# ***82545EM Gigabit Ethernet Controller Specification Update***

***June 6, 2006***

The *82545EM* Gigabit Ethernet Controller may contain design defects or errors known as errata that may cause the product to deviate from published specifications. Current characterized errata are documented in this Specification Update.

## 8. 1.5V Regulator Control Circuit Start Up

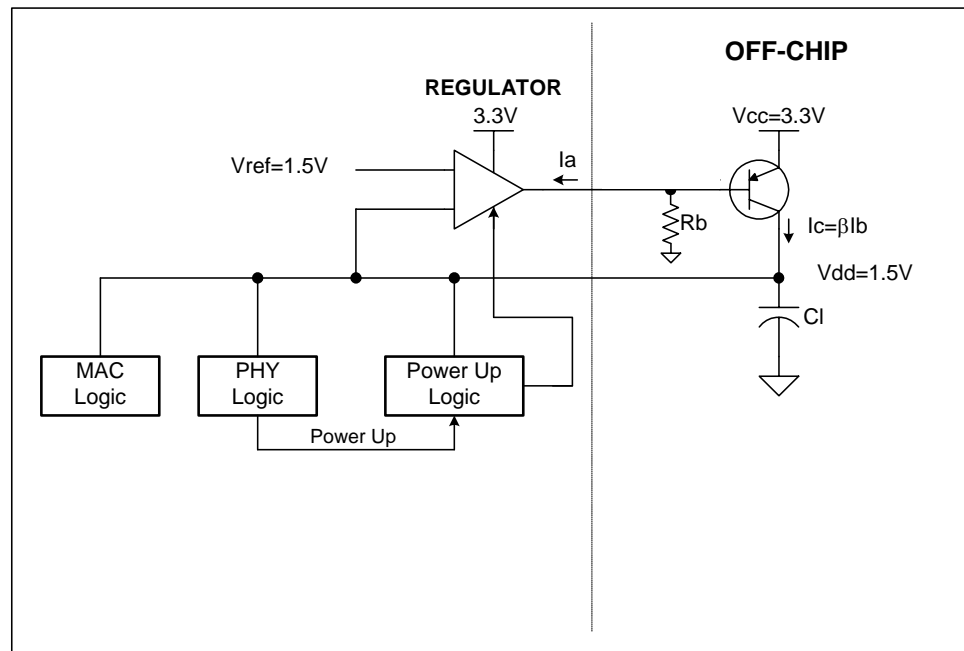
- Problem:** The 82545EM products contain on-chip LDO voltage regulation controllers for both 1.5V and 2.5V. The 1.5V regulator control output, CTRL\_15, sometimes powers up in a high impedance state due to a digital portion of the feedback-control circuit which requires 1.5V to be present to operate correctly. The rate of occurrence of this problem may appear to vary from device to device or with different PNP transistors.

- Implication:** When drive is absent on the CTRL\_15 output, only leakage current from the CTRL\_15 output will be present. Depending on the amount of leakage current and the gain (Beta) of the external PNP transistor, there may be insufficient collector current ( $I_C = I_B * \text{Beta}$ ) to adequately supply the 1.5V rail, and the 1.5V regulator circuit may not turn on. The 1.5V rail requires a minimum collector current of 5 mA to be generated and a 1.5V rail voltage of at least 600 mV to ensure that the digital portion of the circuit turns on correctly.

When the 1.5V regulator control output fails, the 2.5V regulator control output(s) may also fail, driving the 2.5V supply toward either 0V or the 3.3V rail. The absence of one or both of the 1.5V and/or 2.5V supplies prevents the Ethernet controller from operating correctly.

- Workaround:** The regulator control output is Ball A18 on the 82545EM controller. Intel's original reference designs showed two external resistors, R1 and R2, in this circuit. The workaround completely removes R2 and replaces it with another resistor, Rb, connected between the CTRL\_15 output and ground.

For the 82545EM A-1 step: Rb = 15 K $\Omega$  with a  $\pm 5\%$  tolerance.

Systems that generate 1.5V without using the Ethernet controller's onboard regulator control (for example, at a central power supply) do not need a workaround. No changes are required for the 2.5V regulator circuit.

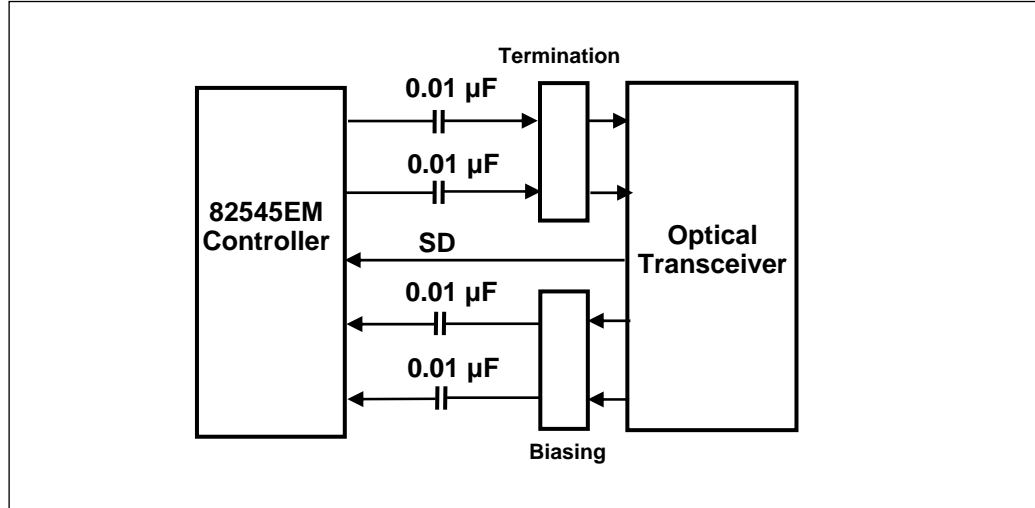
**Problem:** The schematics attached to this Specification Update supercede those in the original design guides. The schematics have not changed after the last Specification Update (0.5).

For the 82545EM Controller, the 0.5 revised schematic dated Sept. 24, 2001 is attached. This schematic did not change since the last Specification Update (0.6). Please note the following errors and omissions:

- The Gigabit Ethernet controller may be referred to as “Kenai 64”, “Anvik”, or “82546EB” on some of the sheets. The correct part reference is 82545EM.

- Some of the sheets refer to “Port 1.” Since the 82545EM controller is a single-port device, these references are irrelevant.
- The circuitry attached to the CTRL\_15 pin requires modification for an erratum described elsewhere in this document.

- Ball A8 should be re-labeled as TEST# and have the pull-down resistor removed. This change is also described elsewhere in this document.

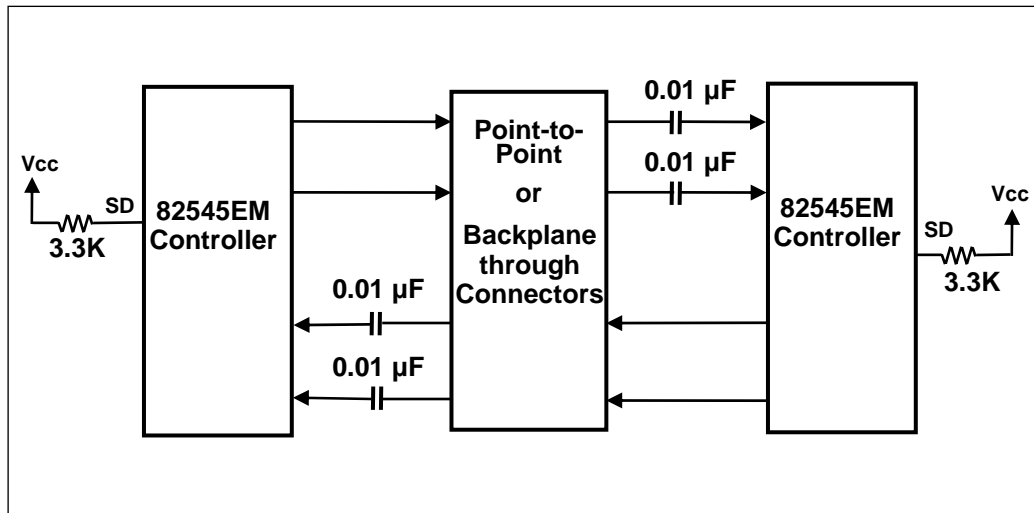
**Problem:** Intel added new SERDES functions to the 82545EM controller. SERDES stands for Serializer-Deserializer and is a circuit that converts Ethernet packet data from a parallel TBI format to a 1.25 GHz bidirectional serial stream. For 1000BASE-SX or 1000BASE-LX fiber applications, SERDES integration typically saves the designer the expense and board space of a 64-lead external device. The 82545EM controller contains one SERDES. A '10' needs to be written in ICW3 bits 1 and 0, respectively, in order to enable this feature.

The datasheet for the 82545EM Controller will change to define pins as follows:

82545EM controller fiber-based applications will use the SERDES interface to drive a 1000BASE-SX or 1000BASE-LX optical transceiver as illustrated in the above figure. The 82545EM controller is internally terminated, so no external termination is required.

Alternatively, the 82545EM may be used in short haul gigabit backplane data applications without transceivers and optical fibers. No special termination is required because the 82545EM device is internally terminated. The figure below illustrates a gigabit backplane or point-to-point circuit based on either the 82545EM device:
